Determination 2017/010

The refusal to issue code compliance certificates for a 21-year-old house with 9-year-old alterations and addition at 28 Christian Road, Swanson

Figure 1: Approximate site plan

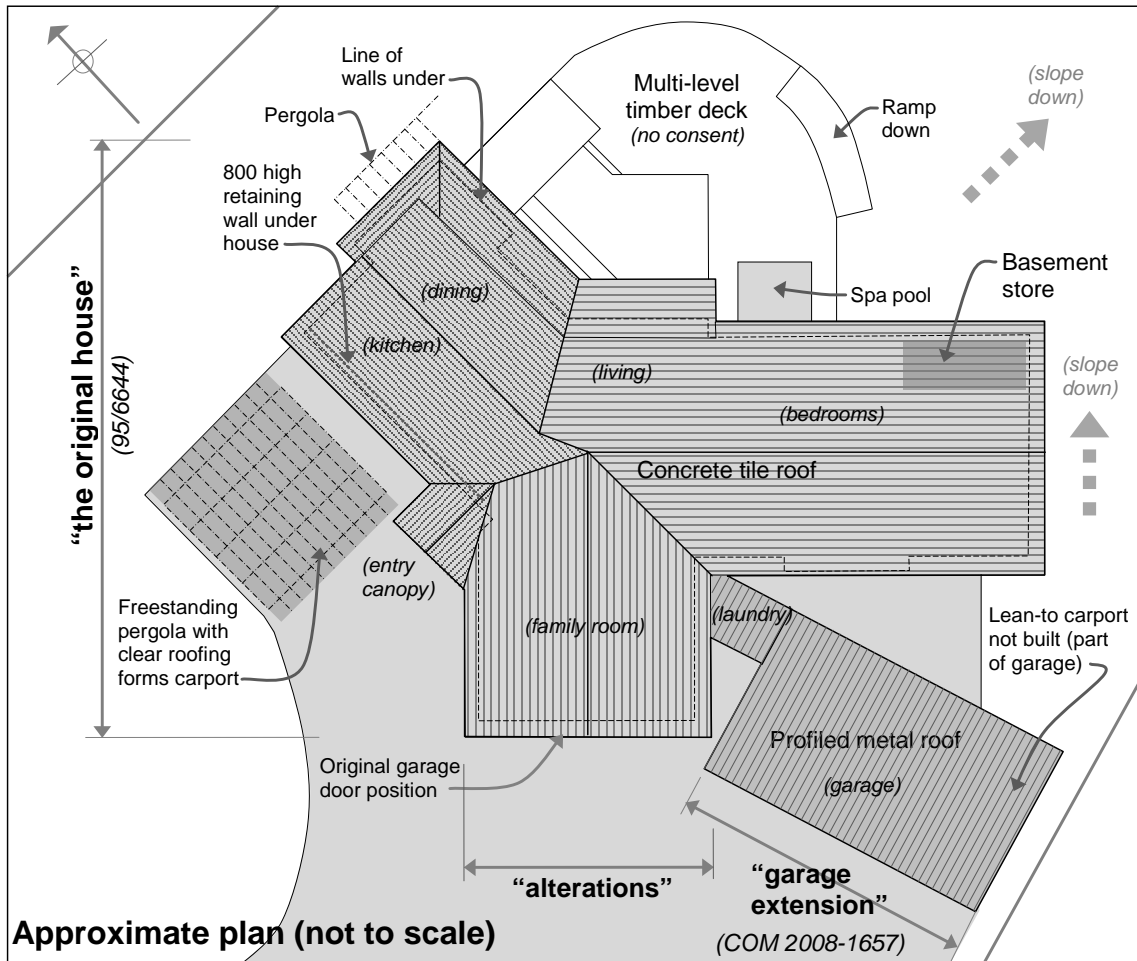
- the backing sheets and plaster extended below the boundary joists by about 50mm to form a drip edge
- clearances from the bottom of the plaster was more than a meter on most of the SE, NE and east elevations (at downhill site levels to east)
- most clearances along the west elevations and the wall were below current recommendations (at uphill site levels to west), with elevated moisture readings in some bottom plates.

- the plaster and backing sheets were installed over drained cavities
- clearances to finished ground level were generally about 150mm, but this reduced towards the garage door, with pebbles covering the base in one area and elevated moisture readings beside the garage door.
